**From:** drainage <drainage@midsussex.gov.uk>  
**Sent:** 04 July 2025 15:25:03 UTC+01:00  
**To:** "Anna Tidey" <anna.tidey@midsussex.gov.uk>  
**Cc:** "drainage" <drainage@midsussex.gov.uk>  
**Subject:** 2025.07.04 Re: DM/25/0579 -Hammonds Mill\_Class Q Application - Request for further information

- Flood Risk Assessment and Drainage Strategy RESPONSE to MSDC Flood Risk and Drainage Team Comments on FRA (UPDATED) - 19 June 2025

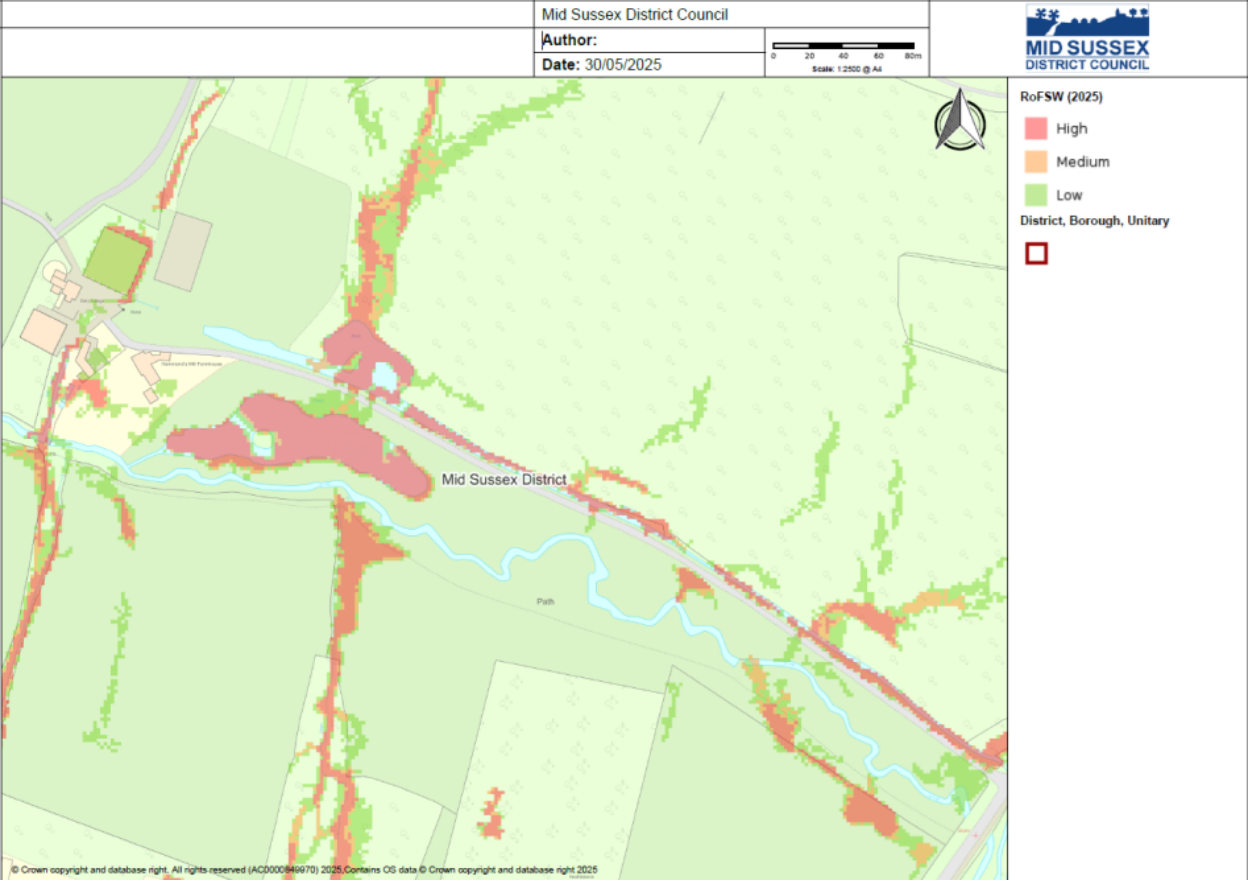
The land immediately north and east of Barns 1 and 2 is shown to be at High Risk from Surface Water Flooding—both at present day and with climate change (between 2040 – 2060) —comparable to Flood Zone 3b.

Flood depths exceeding 0.90m are shown adjacent to the north and east of Barns 1 and 2 for the Low (1:100 + climate change flood extent analogue).

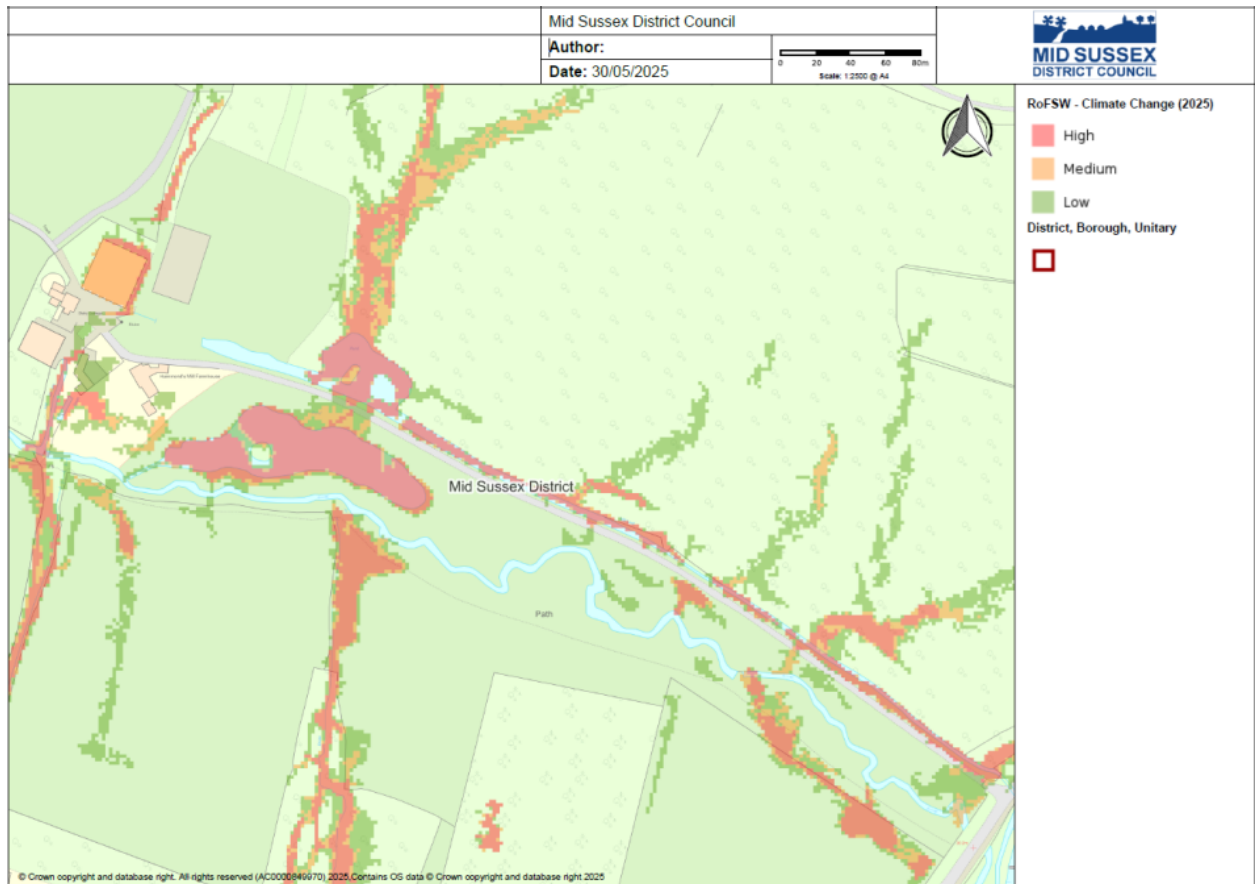
Flood depths exceeding 0.30m are shown with the footprint of Barns 1 and 2 for the Low (1:100 + climate change flood extent analogue).

Barns 1 and 2 would appear to be partially open sided, which could allow depths of 0.90m of surface water to enter the barn.

In line with the Environment Agency's Standing Advice, the applicant must demonstrate how the development will be protected from surface water flooding—this includes raising finished floor levels above the estimated surface water flood depths.

As such, the finished floor level of Barns 1 and 2 should be at least 300mm above adjacent ground level, with an additional 600mm of flood risk mitigation.
